**COMMITTEE OF EXPERTS ON THE TRANSPORT OF
DANGEROUS GOODS AND ON THE GLOBALLY
HARMONIZED SYSTEM OF CLASSIFICATION
AND LABELLING OF CHEMICALS**

**MISCELLANEOUS PROPOSALS OF AMENDMENTS TO THE MODEL
REGULATIONS ON THE TRANSPORT OF DANGEROUS GOODS**

Protection of shell and service equipment on portable tanks

Transmitted by the expert from Australia^{*}

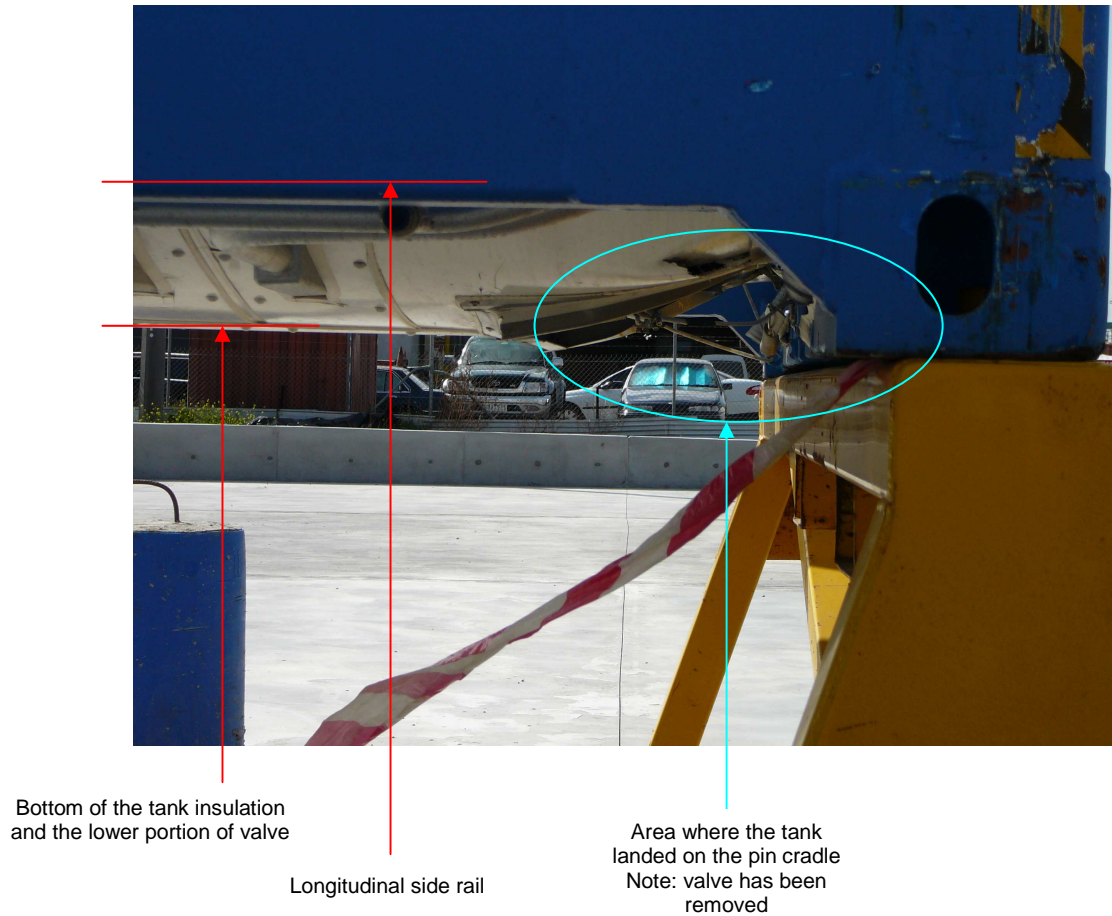
4. In September 2007, an insulated portable tank complying with tank instruction T11 and containing Ethyl Acrylate (UN1917) was being discharged from a container ship using a container gantry crane. Due to the use of automatic and semiautomatic twist locks, the standard practice is to land tanks and containers on a ‘pin cradle’ to facilitate the fitting or removal of twist locks. When the tank was landed on the cradle it was slightly misaligned longitudinally. As a result the tank did not come to rest on the cradle structure by way of the bottom transverse rail and bottom corner fittings, but rather 120mm - 150mm beyond.

5. The design of the portable tank was such that the bottom of the valve structure, vent fittings and shell insulation all sat below the line of the longitudinal side rails. When the tank was landed without being properly aligned on the cradle, the load was taken by the bottom of the tank and valve (see photograph below). The same situation would occur if the tank had been landed on top of another container in the same manner, noting portable tanks are stacked in ship board stows and container terminals, so the risk is not isolated to the use of materials handling equipment such as pin cradles.

Damaged Valve stem

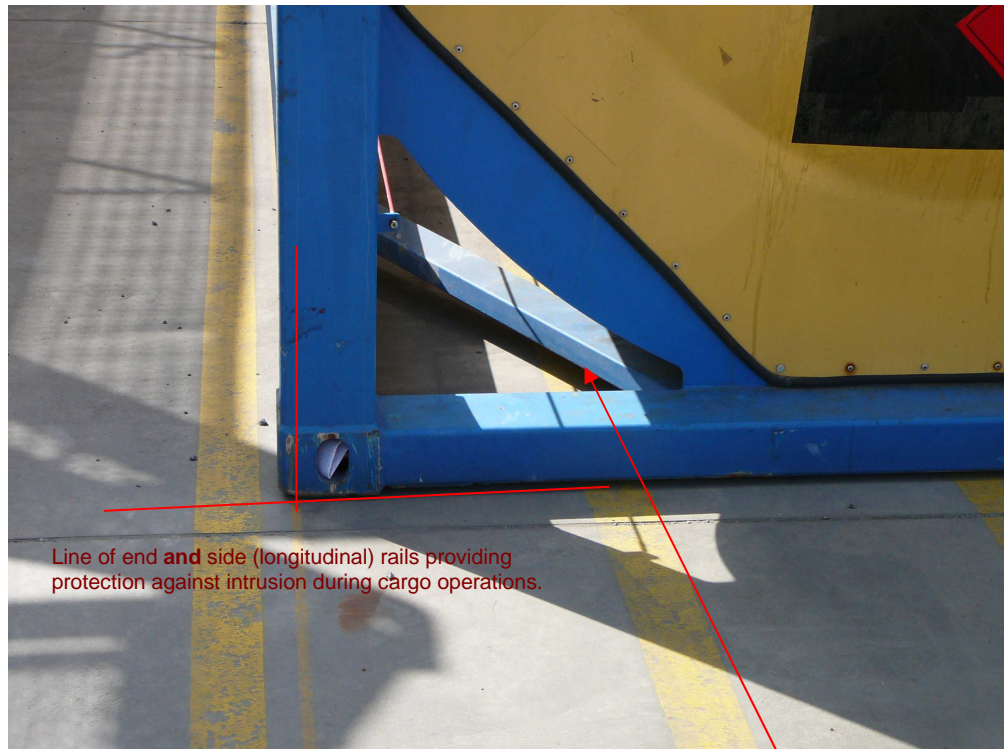
6. As a result of the landing, the insulation and vent lines were pushed up and a securing bracket on the vent lines was sheared. More seriously, the valve stem was pushed up and sheared off at the flange. The impact was also sufficient to displace the internal stop valve resulting in a slow leak of the contents from the tank. While compliance with section 6.7.2.6.3 should have prevented displacement of the foot valve, it appears the amount and type of damage to the valve stem may have made the leak inevitable. The level of protection of the valve stem was a major factor in this incident.

Displaced vent line and sheered bracket
